# Technical Bulletin

**58 12 05** November 2, 2012 **2021668** Supersedes T. B. V580902 dated October 5, 2009 to update water test labor operation.

### Rear Doors, Outer Seal, Water Retention at Sill Plate

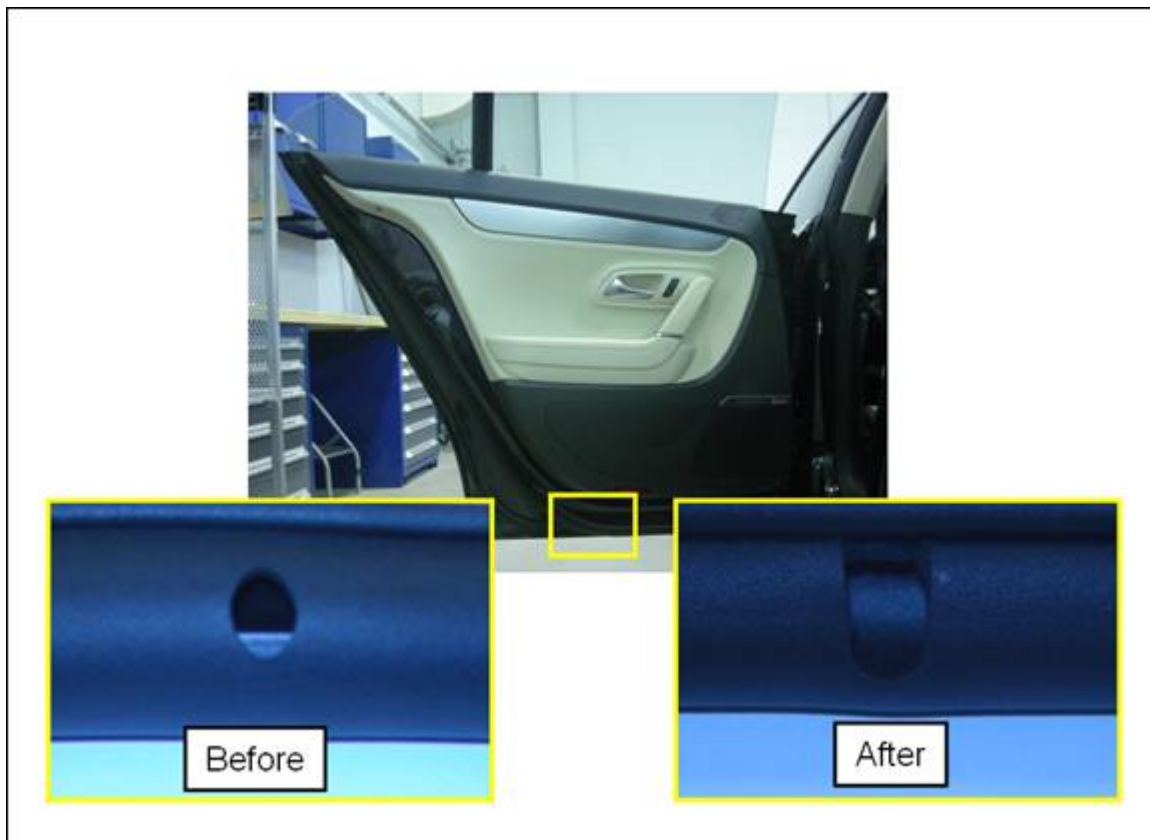
Water is collecting between lower door seal and lower body seal of the rear doors.

New design rear outer door seals.

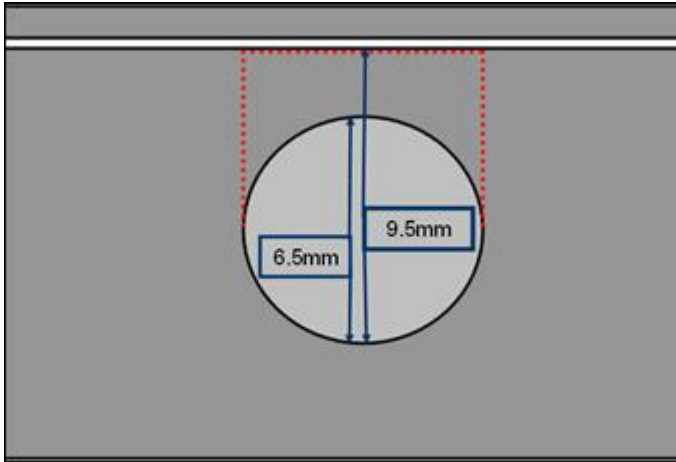
1. Locate rear door outer seal inner drain hole, see photo below.

2. Elongate drain hole in rear door outer seal using scissors or side cutters from 6.5mm round opening to a 9.5mm squared off opening, see photo below.

3. Water test vehicle after seal modification and verify vehicle is not retaining an abnormal amount of water in the rear door area.
4. If an abnormal amount of water is spilled out after seal modification, replace rear door outer seal. Refer to Repair Manual Group 58, *Rear Doors, Removal and Installation, Rear Door Components*.
